JOSEPH M. FARLEY NUCLEAR PLANT-UNIT 2
ALABAMA POWER COMPANY
REPORT OF 10CFR50.55(e) DEFICIENCY

FIGURE 1 PRESENT CONFIGURATION-TRAIN A

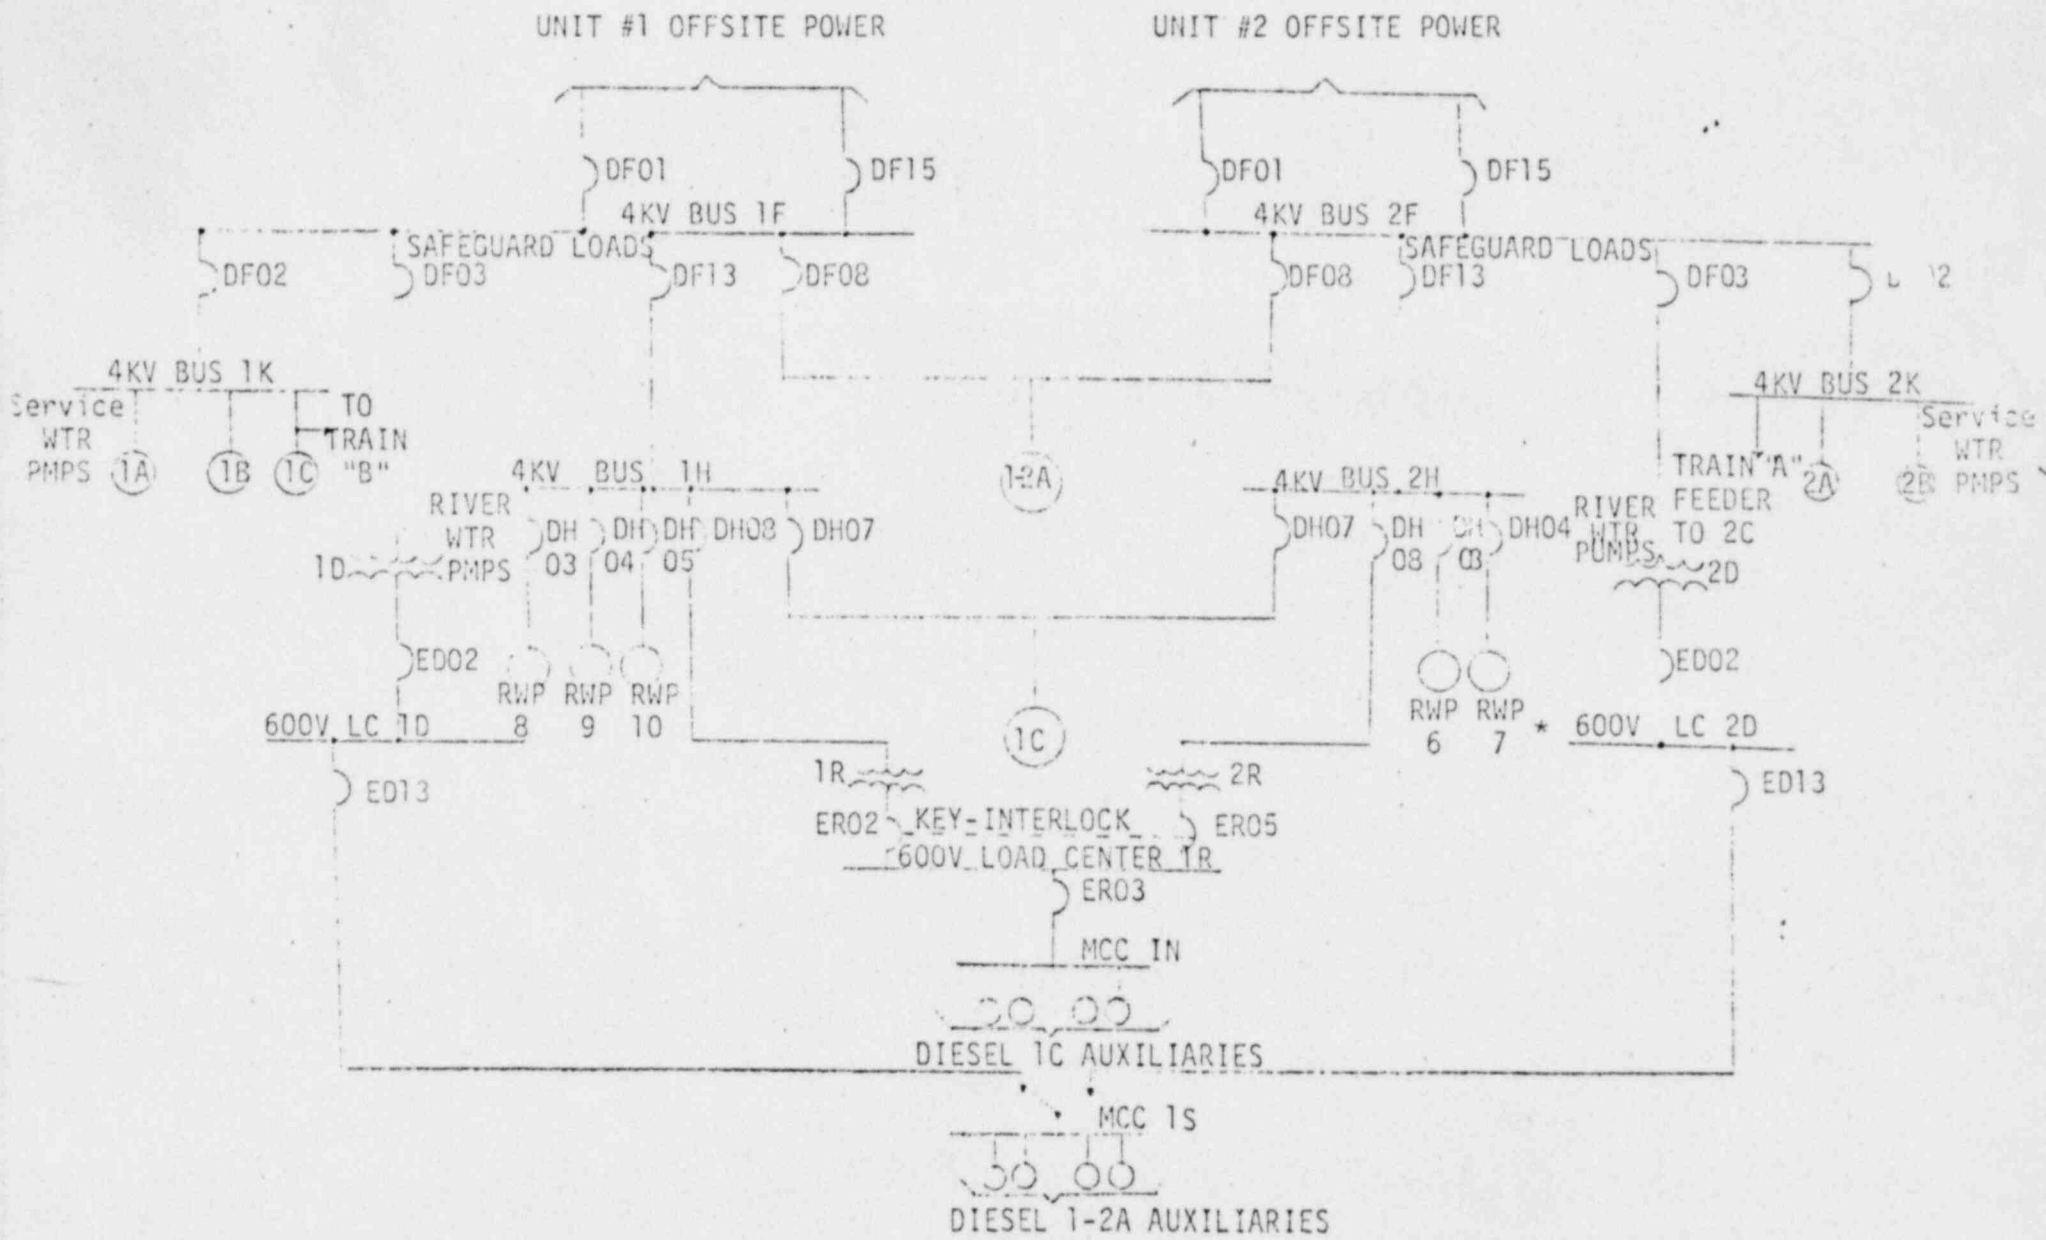
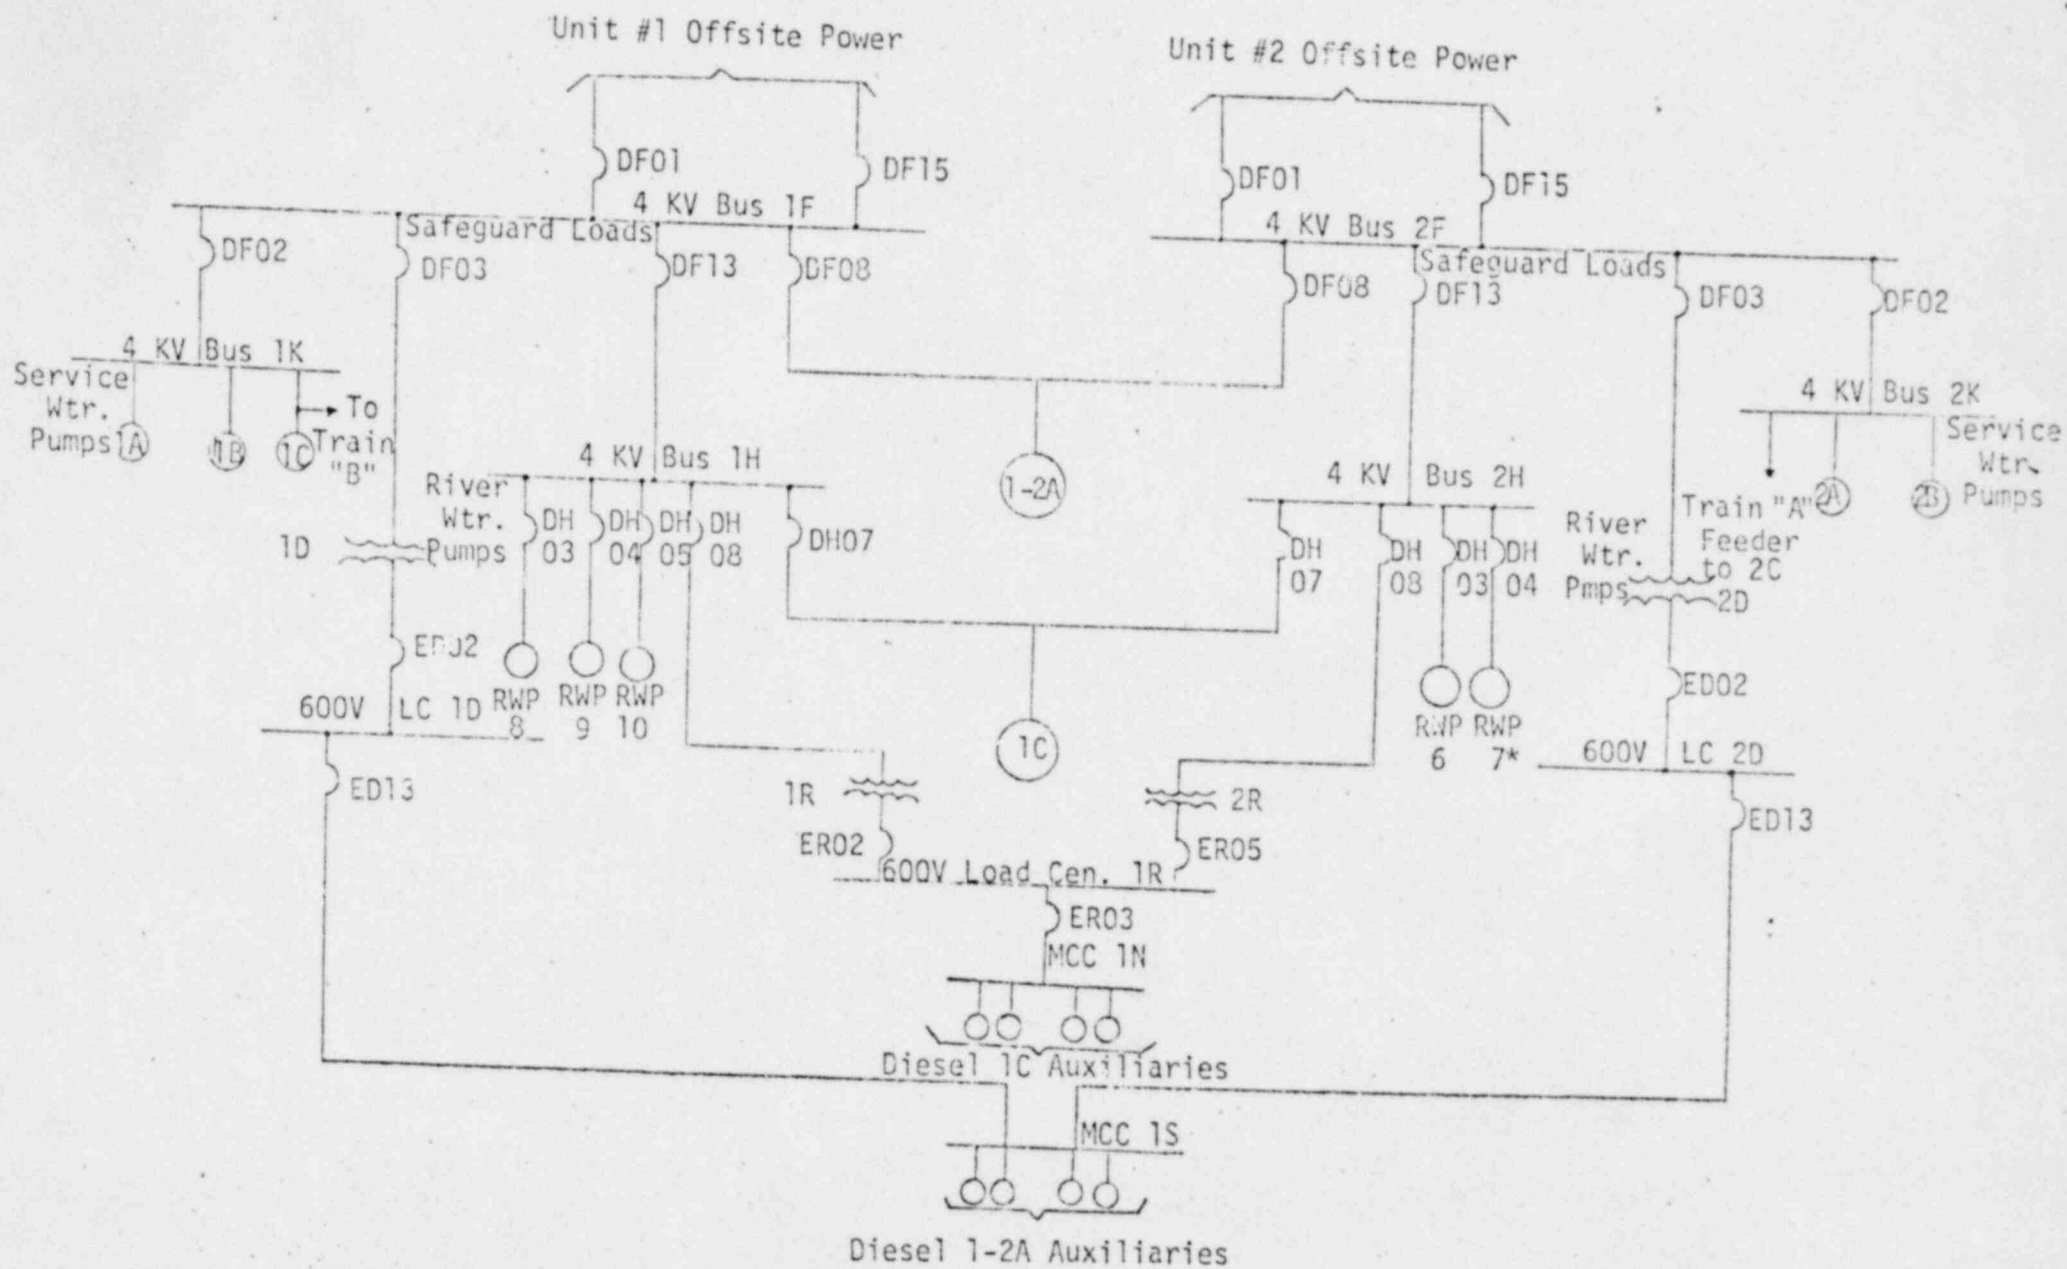
A design condition has been detected which can render Diesel Generator 1C and 1-2A inoperable when both Farley units are in operation and loss-of-offsite power (LOSP) on both units or LOSP on both units and LOCA on one unit occur.

Presently, as shown in Figure 1, Diesel Generator 1C has its auxiliaries powered from emergency Motor Control Center (MCC) 1N. MCC 1N gets its power supply from emergency 600V Load Center 1R. The 600V Load Center 1R is a shared load center capable of being energized from either unit. When it is energized from Unit 1 it is supplied from the 4KV Bus 1H through Station Service Transformer 1R. When it is energized from Unit 2 it is supplied from the Unit 2 4 KV Bus 2H through Station Service Transformer 2R. The two 600V incoming breakers of 600V Load Center 1R are key interlocked so that only one can be closed at any time. The alignment of Load Center 1R to Unit 1 or Unit 2 can be performed manually only, from the local control panel located in the diesel building.

As shown in Figure 1, Diesel Generator 1-2A has its auxiliaries powered from emergency MCC 1S. MCC 1S is a shared MCC capable of being energized from either unit. When it is energized from Unit 1 it is supplied from the Unit 1 600V Load Center 1D, which in turn is powered from Unit 1 4KV Bus 1F through Station Service Transformer 1D. When it is energized from Unit 2 it is supplied from the Unit 2 600V Load Center 2D, which in turn is powered from Unit 2 4 KV Bus 2F through Station Service Transformer 2D. The alignment of MCC 1S to Unit 1 or Unit 2 can be performed manually only from the MCC 1S located in the diesel building.

Under LOSP on both units or LOSP on both units and LOCA on Unit 1, Diesel 1C is a source of power for Unit 2 Train A hot shutdown loads, while Diesel 1-2A is a source of power for Unit 1 LOCA loads. If, at the accident occurrence, 600V Load Center 1R is aligned to Unit 1, it will be deenergized since 4 KV Bus 1H is deenergized, and Diesel Generator 1C loses its auxiliaries. At this time, MCC 1N

has to be connected to Station Service Transformer 2R by the manual operation of the key interlocked incoming breakers of 600V Load Center 1R. Diesel generator manufacturer has specified that diesel generator can run without its auxiliaries for one minute if the engine is at operating temperature, or for three minutes from cold start. If the manual changeover of power source to MCC 1R cannot be accomplished in the specified time, Diesel Generator 1C could be automatically tripped because of low lube oil pressure, or damaged because of loss of cooling water. The high cooling water temperature is alarmed, but does not trip the diesel generator automatically under accident conditions.

If Diesel Generator 1C is disabled, no source of power for Unit 2 Train A safeguard loads will be available, and a single failure on Unit 2 Train B can render Unit 2 incapable of being shutdown. (4 KV Bus 1H is deenergized under the postulated conditions since the tie breaker between 4 KV Bus 1F and 4 KV Bus 1H is open.)

If, under the above conditions MCC 1S is aligned to Unit 2, it will be deenergized and Diesel Generator 1-2A loses its auxiliaries. If Diesel Generator 1-2A is disabled, no source of power for Unit 1 Train A LOCA loads will be available. In this case, if we apply the single failure criterion to Unit 1 Train B instead of Unit 2 Train B, Unit 2 will meet the hot shutdown requirements, while Unit 1 cannot meet the LOCA requirements.

Under LOSP on both units and LOCA on Unit 2, Diesel Generator 1C is the source of power for Unit 1 Train A hot shutdown loads, while Diesel Generator 1-2A is the source of power for Unit 2 LOCA loads. If, at the accident occurrence 600V Load Center 1R is aligned to Unit 2, it will be deenergized since 4 KV Bus 2H is deenergized, and Diesel Generator 1C loses its auxiliaries. Diesel Generator 1C will be disabled, no source of power for Unit 1 Train A safeguard loads will be available, and a single failure on Unit 1 Train B can render Unit 1 incapable of being shutdown. (4 KV Bus 2H is deenergized under the postulated conditions since the tie breaker between 4KV Bus 2F and 4 KV Bus 2H is open.)

If, under the above conditions MCC 1S is aligned to Unit 1, it will be deenergized, Diesel Generator 1-2A disabled, and no source of power for Unit 2 Train A LOCA loads will be available. In this case, if we apply the single failure criterion to Unit 2 Train B instead of Unit 1 Train B, Unit 1 will meet the hot shutdown requirements, while Unit 2 cannot meet the LOCA requirements.

Thus, under the criteria of 10CFR50.55(e) the referenced problem constitutes a significant deficiency. Note that the referenced problem is only a safety problem when Unit 1 and Unit 2 are operated simultaneously.

To correct the first problem the following corrective action will be taken (refer to Figure 2):

(1) The key interlock feature of breakers ER02 and ER05 on Load Center 1R will be removed and replaced by an electrical interlock, so that only one of the two breakers could be closed at any time.

The electrical circuitry of these breakers will be changed to accomplish the following: (a) automatically connect Load Center 1R to Bus 1H (ER02 closed and ER05 open) when Diesel Generator 1C is aligned to Unit 1 (DH07 on Bus 1H closed); (b) automatically connect Load Center 1R to Bus 2H (ER05 closed and ER02 open) when Diesel Generator 1C is aligned to Unit 2 (DH07 on Bus 2H closed).

(2) Manual transfer switch on MCC 1S will be removed and the incoming feeders from Load Centers 1D and 2D will be solidly connected to the MCC.

Breakers ED13 on Load Center 1D and ED13 on Load Center 2D will be electrically interlocked, so that only one of the two breakers could be closed at any time. The electrical circuitry of these breakers will be changed to accomplish the following: (a) automatically connect MCC 1S to Load Center 1D (ED13 on Load Center 1D closed and ED13 on Load Center 2D open) when Diesel Generator 1-2A is aligned to Unit 1 (DF08 on Bus 1F closed); (b) automatically connect MCC 1S to Load Center 2D (ED13 on Load Center 2D closed and ED13 on Load Center 1D open) when Diesel Generator 1-2A is aligned to Unit 2 (DF08 on Bus 2F closed).

FIGURE 3 PRESENT CONFIGURATION -TRAIN B
(The corrective action necessitates no change to this figure.) * Manually Loaded

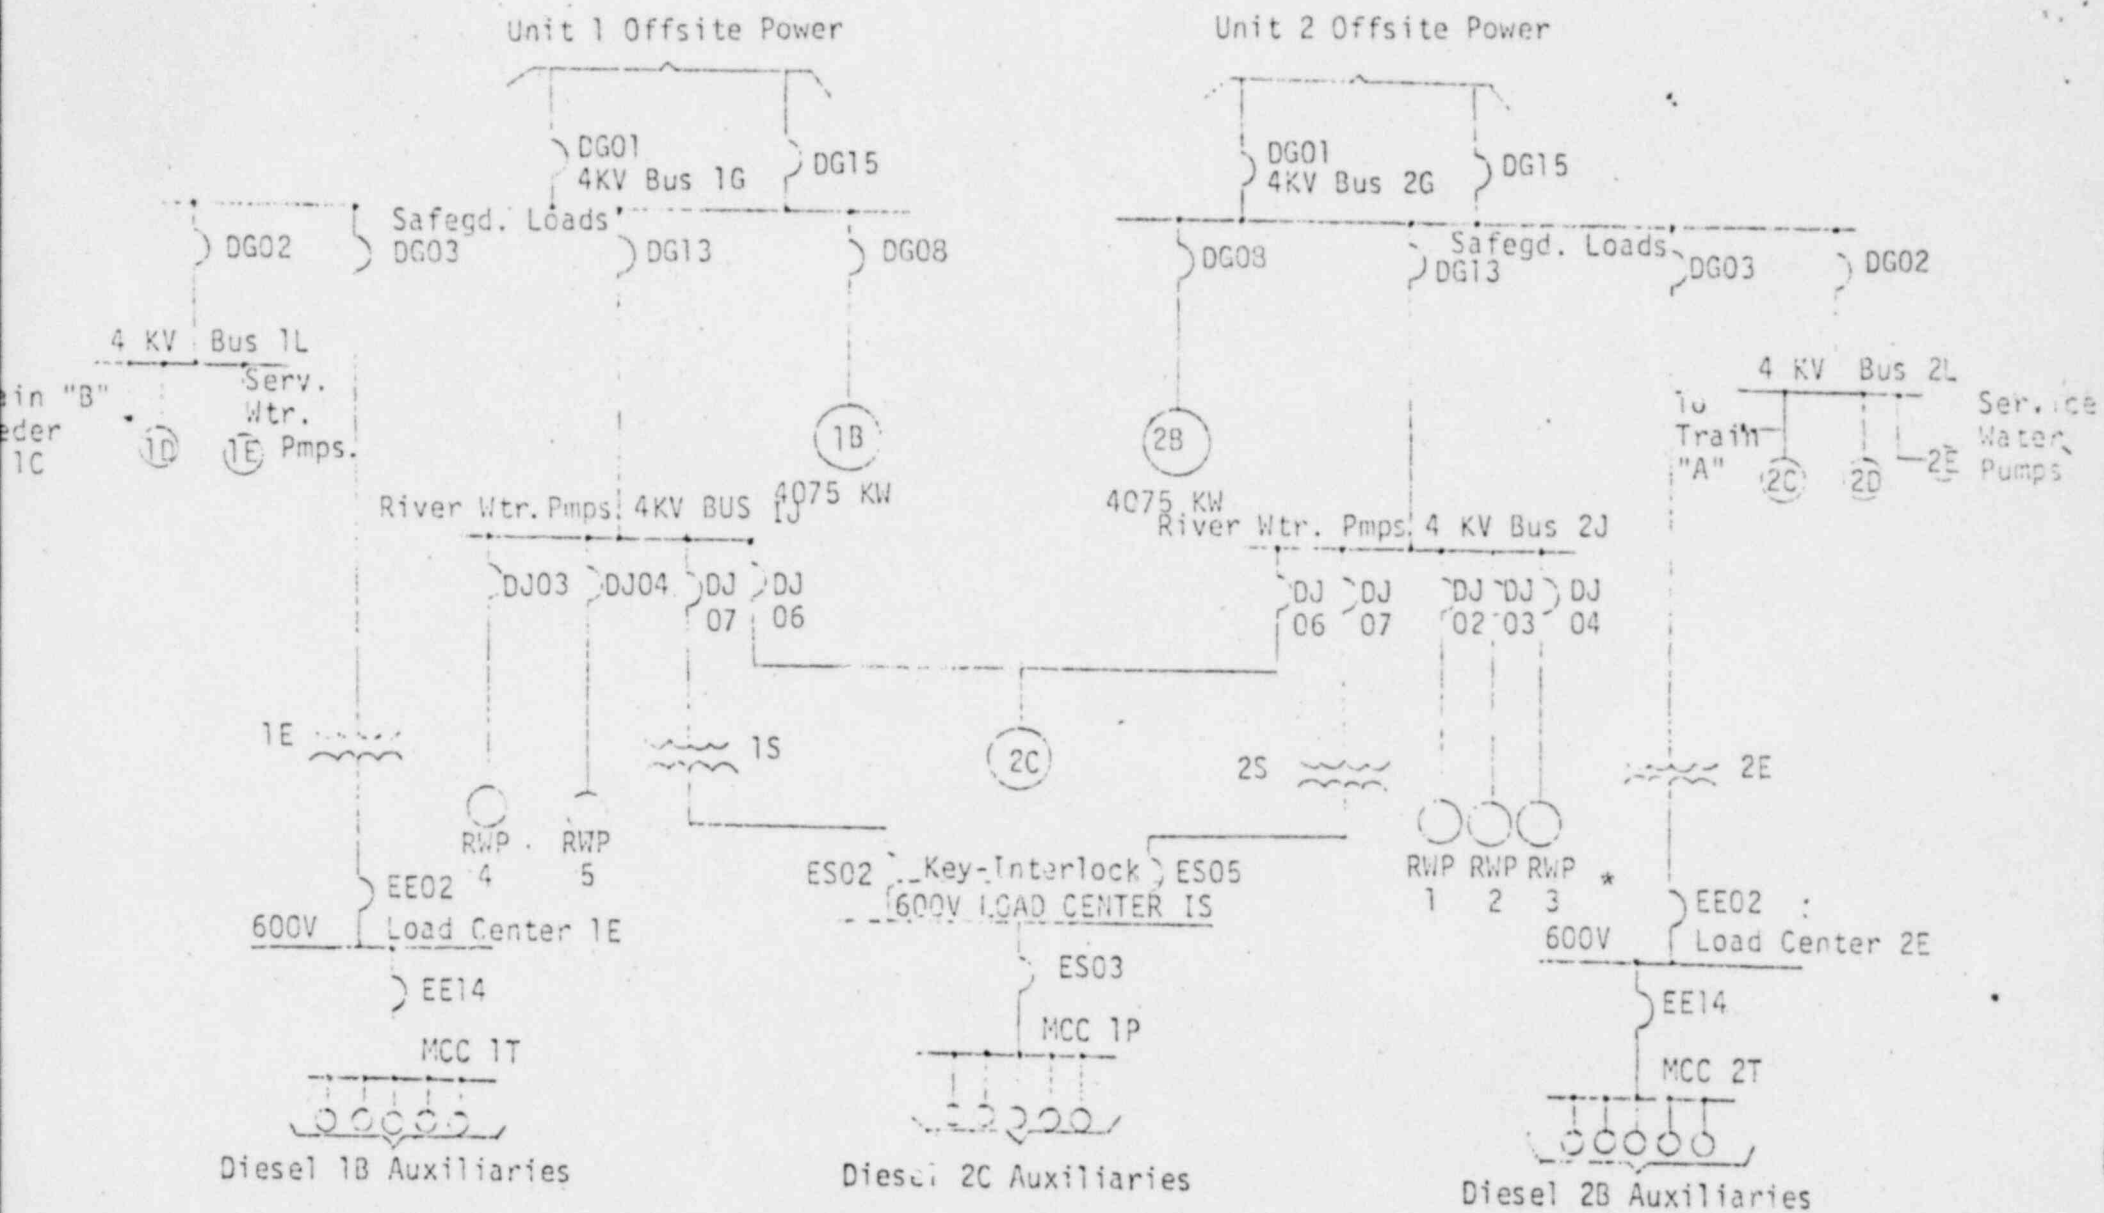
A second problem identified concerning the diesel generator relates to the following. The Farley Nuclear Plant is intended to be designed to accommodate the Loss of Pond Dam along with Loss-of-Offsite Power and a single failure. Under this event, the river water systems will be automatically diverted to the wet pit which supplies suction to service water pumps.

For this event, for Unit 1 operation alone, a minimum of 2 river water pumps will be required. Therefore, to accommodate single failure, 4 river water pumps are powered from the diesel generator system.

For Unit 1 and Unit 2 operation, a minimum of 4 river water pumps are required and to accommodate single failure, 8 river water pumps are to be sequenced onto the diesel generator system.

With Unit 1 in operation alone two (2) emergency power sources (diesel generator 1C-Train A and diesel generator 2C-Train B) are dedicated to the River Water System. Four river water pumps with automatic starting capability are available so that in the event of single failure at least 2 river water pumps will start, meeting the minimum requirements for safe shutdown of the unit. Therefore, there is no deficiency for Unit 1 operation.

However, after two units go into operation, only one emergency power source (diesel generator 2C-Train B) is dedicated to the River Water System, hence only

4 river water pumps with automatic capability would be available. The failure of diesel generator 2C could leave the entire plant with no river water pumps available. This deviates from our commitment in the FSAR and does not meet the minimum River Water System availability requirements for safe shutdown of both Units. Redesign to provide a minimum of four river water pumps on Loss of Offsite Power is underway.

In order to correct the second problem, the following changes to the logic, schematic, and wiring concerning the diesel generator are proposed (see Figures 1, 2 and 3):

(1) After the sequencer has added the LOSP loads to Bus 1F, the 4 KV Bus 1F will furnish power to the 4 KV Bus 1H. Three Unit 1 Train A river water pumps (Numbers 8, 9, and 10) will be started on Bus 1H in sequence.

(2) The LOSP sequencer on Bus 2F will be modified to eliminate containment cooler 2B from being added automatically. As in the past, containment cooler 2A will be automatically applied to Bus 2F. After LOSP sequencer has added LOSP loads to Bus 2F, the river water pumps sequencer on Bus 2H will be unblocked to enable one river water pump (Number 6) to automatically be applied to Bus 2H.

(3) Should diesel generator 2C fail, diesel generator 1B will furnish power to Bus 1J and diesel generator 2B will furnish power to Bus 2J after the sequencers on Buses 1G and 2G have had LOSP loads added. Two river water pumps (Numbers 4 and 5) will start on Bus 1J and two river water pumps (Numbers 1 and 2) will start on Bus 2J.

(4) The existing feature of the diesel generator 2C working like a backup for diesel generator 1B or 2B if either fails to furnish power to the hot shutdown load will be removed. This feature is not required to meet single failure criteria.

In the design event discussed, the river water system will be automatically diverted to the pond wet pit which supplies suction to the service water pumps. Additional stop logs will be added to the pond wet pit to ensure that adequate wet pit level is maintained.
